Tracked Changes: Design and Development Overlay

SCHEDULE 13 TO THE DESIGN AND DEVELOPMENT OVERLAY

WEST HAWTHORN AREA

Tracked Changes: Local Policy

MAP 1: WEST HAWTHORN AREA AND PRECINCTS

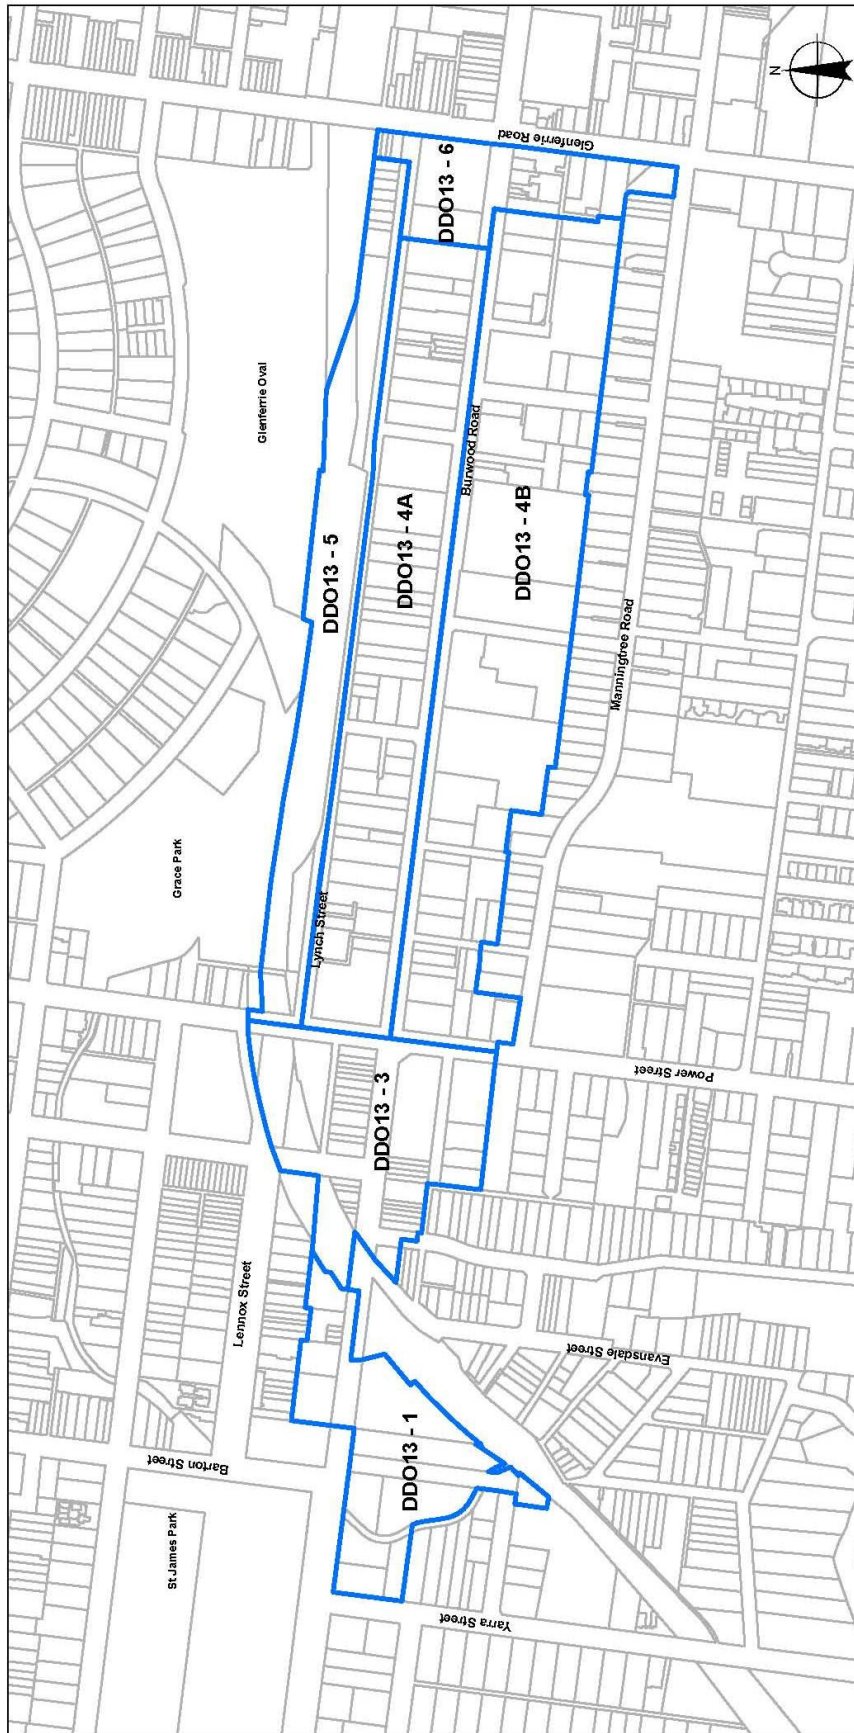
Note: Controls for Precincts 2 and 7 were not adopted

MAP 1: WEST HAWTHORN AREA AND PRECINCTS

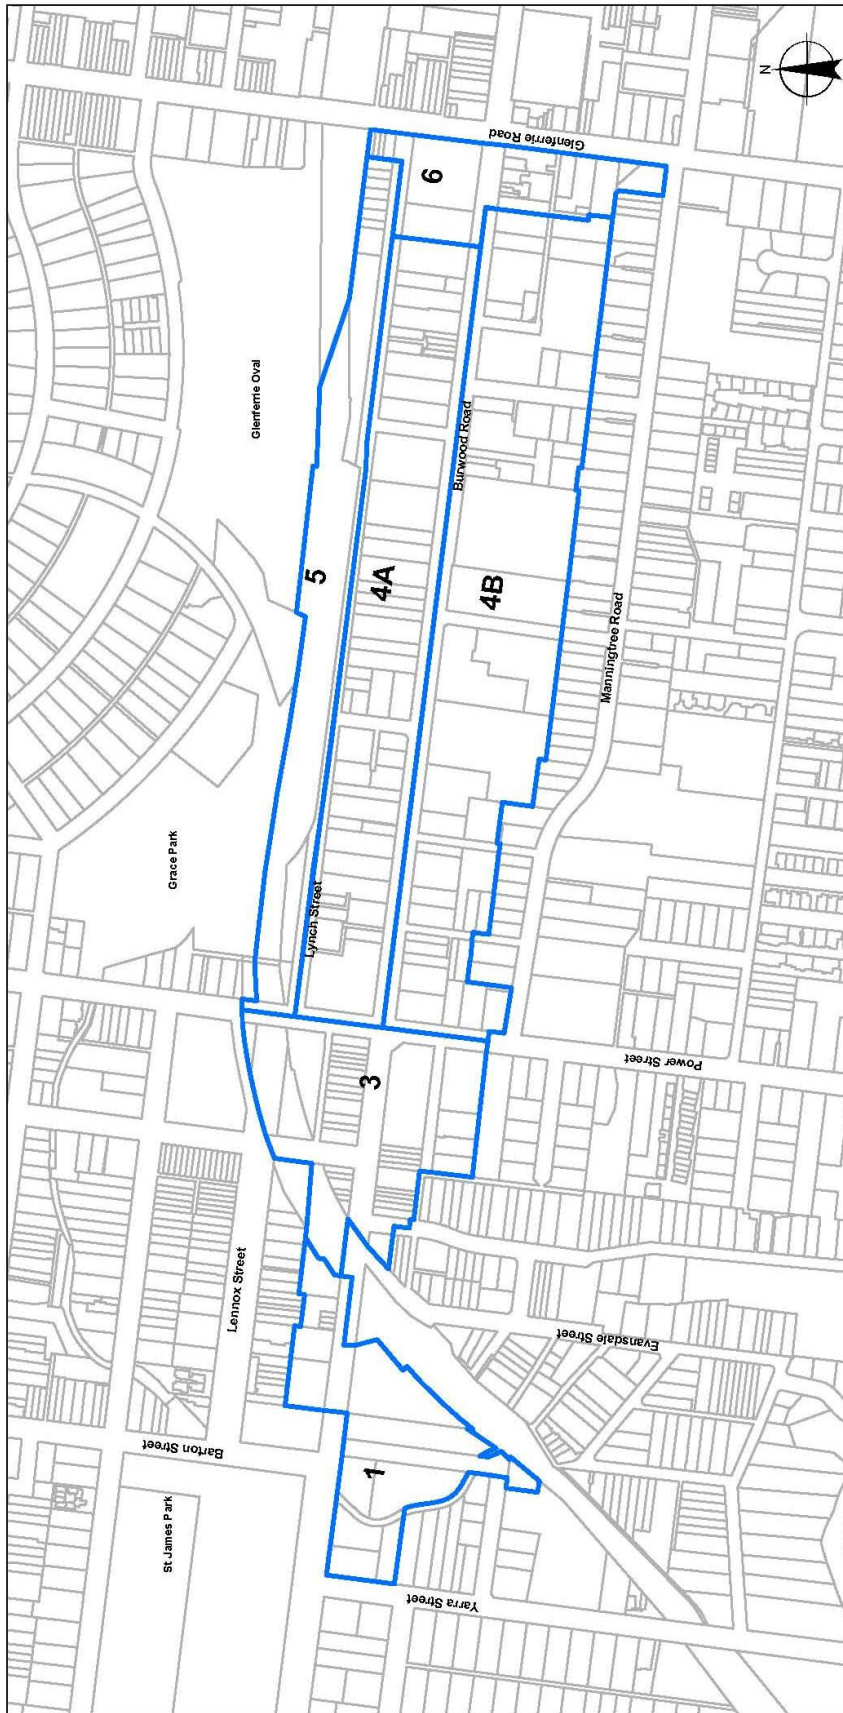
Note: Controls for Precincts 2 and 7 were not adopted
